Memo To: Paul Allore
Memo From: Martin T. Auer
Date April 30, 2015
Subject: York Region Technical Memorandum – Actiflo – March 11, 2015
cc: Jennifer Danahy

Figure 1. Stored phosphorus content of *Cladophora* at Whitby, ON in 1972 compared with contemporary measurements at other sites on Lake Ontario. *Cladophora* nutrient status at Ajax, ON presently lies in the transition region between P-saturation and P-limitation.

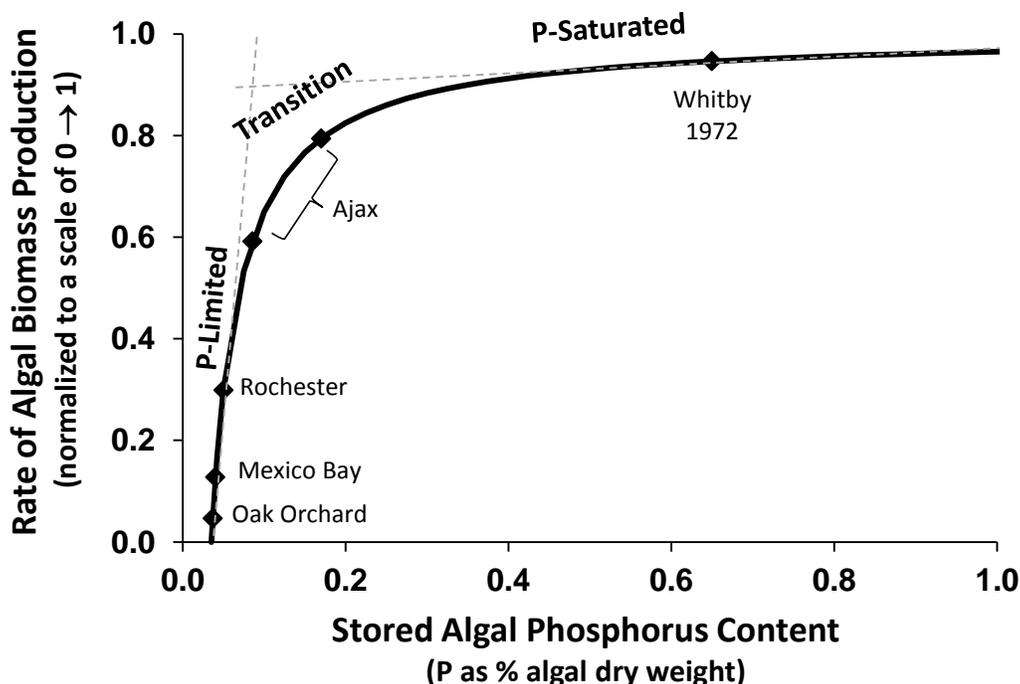
- a) *Non-linearity of the response curve* - it is incorrect to assume that the relationship between phosphorus discharges and the production of *Cladophora* biomass is linear. This relationship has, in fact, been demonstrated to be decidedly non-linear (Tomlinson et al. 2010). Hyperbolic relationships between phosphorus nutrition and *Cladophora* production demonstrates that significant levels of P removal may be achieved before the receiving water reaches a condition of P-limitation. This is clearly demonstrated by measurements of stored P content for *Cladophora* from Lake Ontario (Figure 1) where samples collected at Whitby, ON in 1972 (Painter and Kamaitis 1987) are P-saturated and samples representing contemporary conditions on the south shore of Lake Ontario are P-limited (Higgins et al. 2012). Stored P content at Ajax presently lies at the point of transition from P-saturated to P-limited conditions (Higgins et al. 2012; Auer et al.

2014). For this reason *Cladophora* nutrition along the Pickering-Ajax-Whitby nearshore would be expected to be sensitive to reductions in P loads.

The objective in controlling nuisance growth of *Cladophora* is to maintain bioavailable phosphorus (i.e. fully realized SRP) levels within the linear, P-limited region of the phosphorus response curve (Figures 1 and 3). On a stored P level, this would be <0.1 P as %DW (Figure 1); for SRP, this would be a concentration ~ 1 $\mu\text{gP/L}$ (Figure 3). At present, the bioavailable P concentration of the Duffin Creek WPCP effluent is 292 $\mu\text{gP/L}$ (Auer et al. 2015a). *In order to meet the management objective, the WPCP effluent bioavailable phosphorus concentration must be reduced from 292 $\mu\text{gP/L}$ at its point of discharge to ~ 1 $\mu\text{gP/L}$ at the point that the plume encounters and impacts *Cladophora* habitat (A in Figure 3).* For the Duffin Creek WPCP outfall, this reduction is sought through dilution with lake water, i.e. maintenance of a mixing zone. The dimensions of the mixing zone necessary to accomplish the required dilution are determined by the degree of mixing and the difference between the objective concentration and the effluent concentration (A in Figure 3). *At present, the SRP mixing zone for the Duffin Creek WPCP extends over ~ 8 km of the Pickering-Ajax-Whitby nearshore, encountering and*

Figure 2. Comparison of bioavailable phosphorus concentrations in the effluents of the Duffin Creek WPCP (conventional P removal, sampled in 2014) and Metro and the IAWWTP (ballasted flocculation, sampled in 2012 and 2013, respectively).

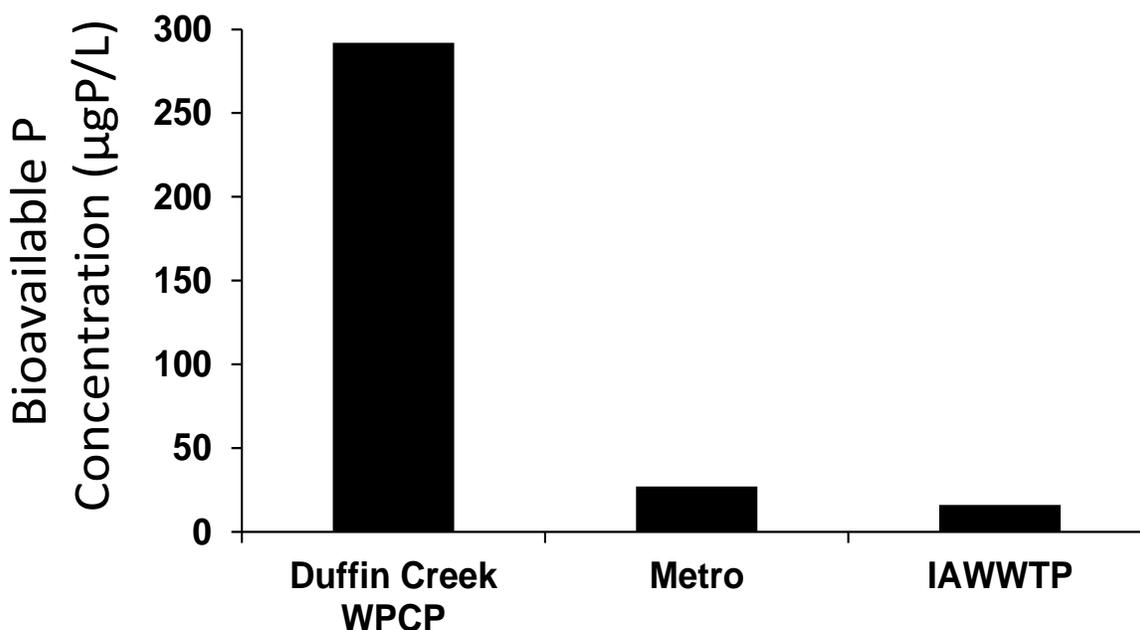
The Great Lakes Water Quality Protocol of 2012 has called for consideration of phosphorus bioavailability in managing loads. Implementation of ballasted flocculation offers benefits in mitigating nuisance algal growth beyond those that may be expressed in terms of the percent reduction in TP load. Ballasted flocculation treatment technology achieves an exceptionally high removal of bioavailable phosphorus by incorporating iron-phosphorus flocs within a sand matrix (ballast) which is efficiently captured through gravitational settling. The Duffin Creek WPCP, which practices conventional chemical removal of phosphorus, discharges an effluent with a

bioavailable P concentration of 292 $\mu\text{gP/L}$ (Auer et al. 2015a). Metro (Lambert et al. 2015) and the IAWWTP (Auer et al. 2015b), both utilizing ballasted flocculation, achieve effluent bioavailable P concentrations of 27 and 16 $\mu\text{gP/L}$, respectively (Figure 2).

Figure 3. Post-discharge mixing and dilution required following conventional and ballasted flocculation treatment for bioavailable phosphorus at the Duffin Creek WPCP (M.T. Auer, unpublished).

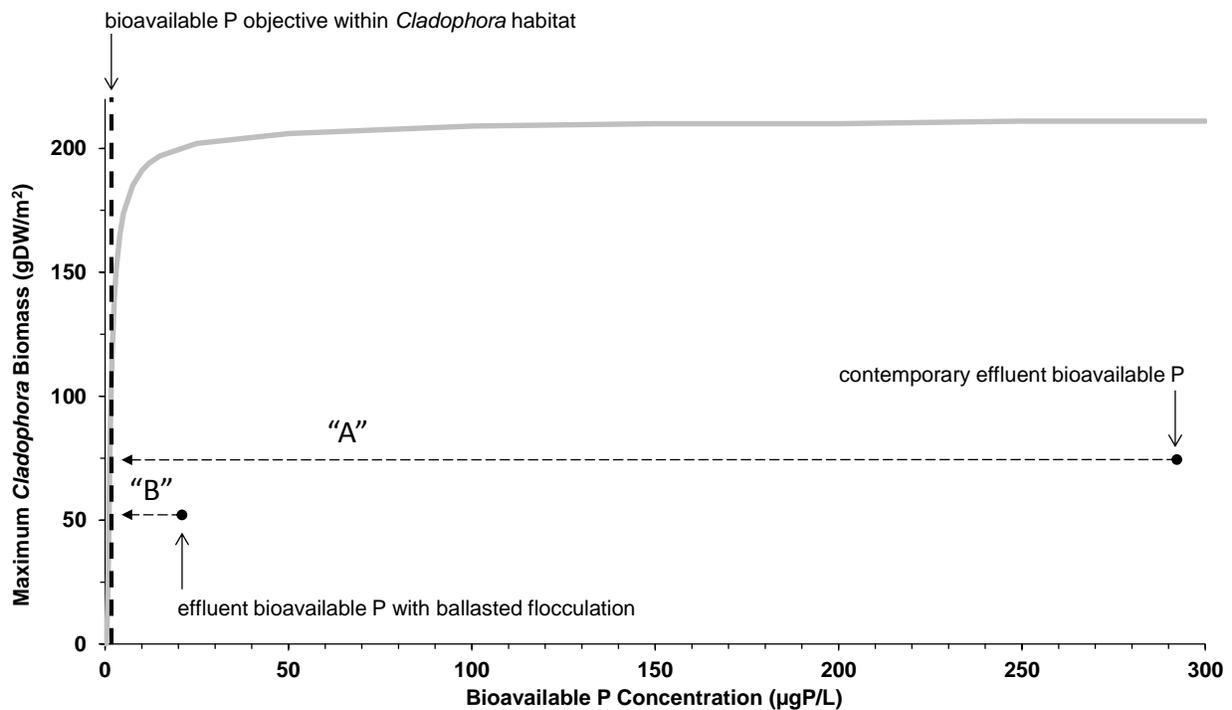
Based on the performance achieved at other facilities (Metro, Lambert et al. 2015 and the IAWWTP, Auer et al. 2015b), implementation of ballasted flocculation at the Duffin Creek WPCP would reduce the bioavailable P concentration of the effluent to 16-26 $\mu\text{gP/L}$. This would markedly reduce the amount of dilution required to bring the effluent bioavailable P down to the concentration objective (B in Figure 3). *The result would be that a smaller area of Cladophora habitat would be impacted by the effluent plume and a lesser degree of pipe extension would be required.*

Our analysis examined the potential impact of ballasted flocculation in terms of bioavailable phosphorus (not simply TP), as recommended by the 2012 Protocol (Figure 3). The 94% removal efficiency for TP presently attained at the Duffin Creek WPCP results in an effluent bioavailable phosphorus concentration of 292 µgP/L (“A” in figure 3). Using the WPCP’s present treatment technology, dilution of the effluent’s bioavailable phosphorus concentration to the 1 µgP/L standard creates a mixing zone extending ~8 km along the Pickering-Ajax-Whitby waterfront. Within that mixing zone, concentrations exceeding the objective are encountered and impact broad areas supporting *Cladophora* growth on the lakebed. *Again, barring improved treatment in the Duffin Creek WPCP, the only solution is to further extend the point of discharge.*

Based on performance at other sewage treatment facilities (e.g. Metro and IAWWTP), the implementation of ballasted flocculation at the Duffin Creek WPCP would lower its effluent bioavailable phosphorus concentration to 16-26 µgP/L (“B” in Figure 3), a reduction of 91-95% BEYOND that presently achieved at the WPCP and a 99⁺% reduction from the concentration entering this WPCP. We note that this extraordinarily effective level of treatment is presently being achieved at WPCPs in several locations.

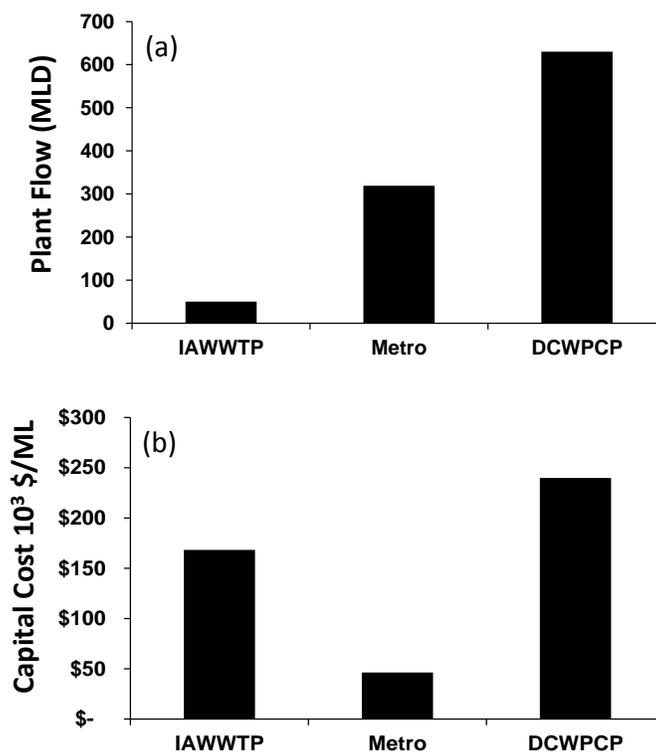
- a) *Capital cost comparisons* – the *Conceptual Design* used in deriving a cost estimate of \$151 million for implementation of ballasted flocculation is based on application of the technology at Metro, yet no side-by-side cost comparison to that facility or others using the technology is presented. Lambert et al. (In Review) report that capital costs at Metro were \$14.8 million (2015 dollars) to treat 319 MLD and \$8.4 million (2015 dollars) at IAWWTP to treat 50 MLD (M.T. Auer, unpublished). *It is recommended that the capital costs estimated for implementation at the Duffin Creek WPCP be compared with the actual capital costs incurred at Metro and the IAWWTP, appropriately scaled to plant size and infrastructure requirements (Figure 4).*
